REMARKS

Amendments to the Drawings

AMENDMENTS TO THE DRAWINGS

FIG. 11

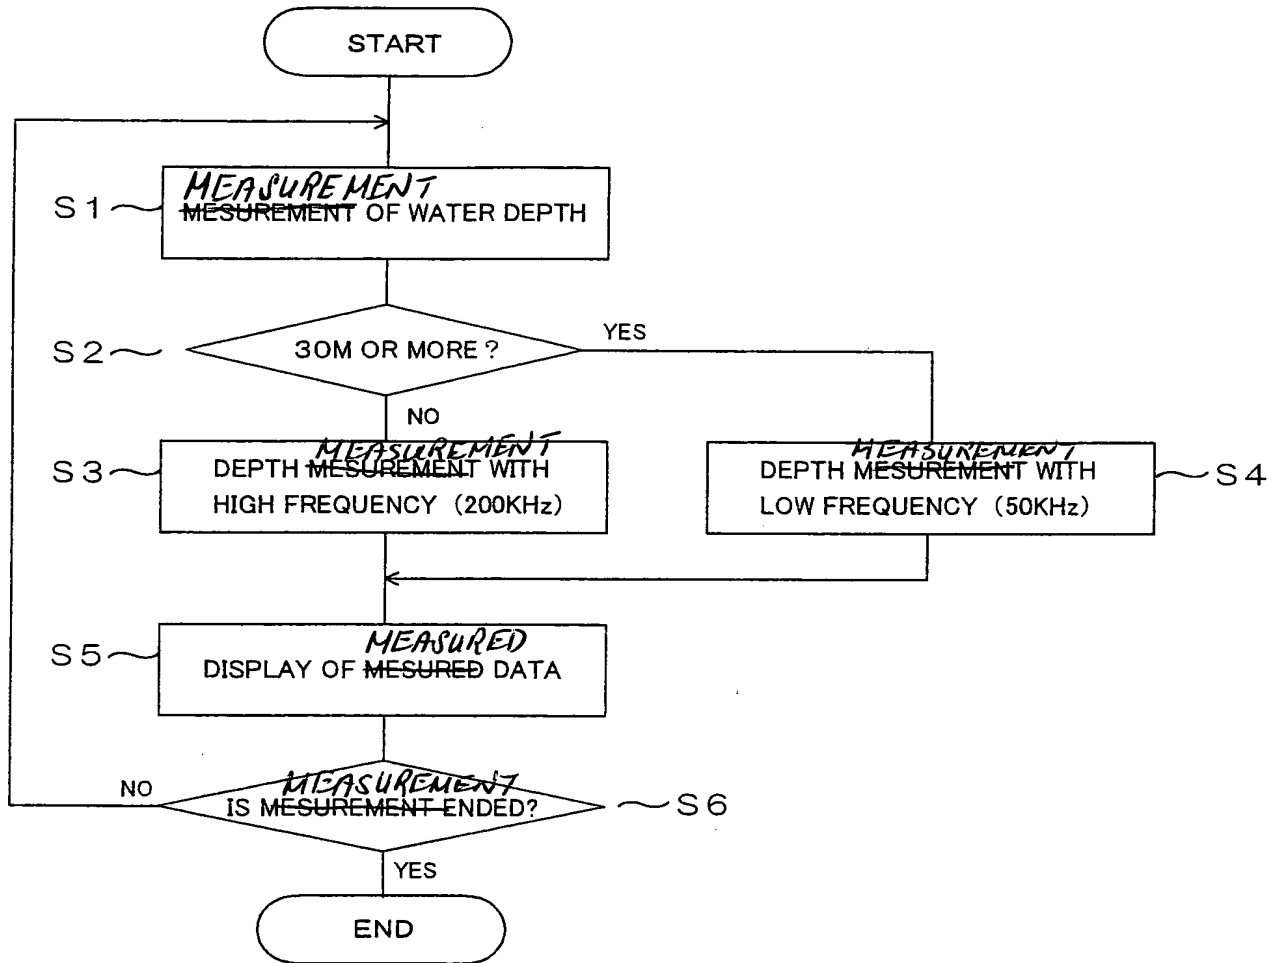
In the outstanding Office Action, the Examiner objected to Figures 11, 12, and 24 because they contained typographical errors. Applicants submit herewith replacement sheets to address said typographical error and respectfully request the objection to the drawings be withdrawn. Marked-up copies of these figures, indicating changed in red ink, are also being provided as a courtesy to the Examiner.

Figures 11, 12 and 24 are changed to correct various typographical errors. Marked-up copies of the drawings are provided indicating changes made in red.
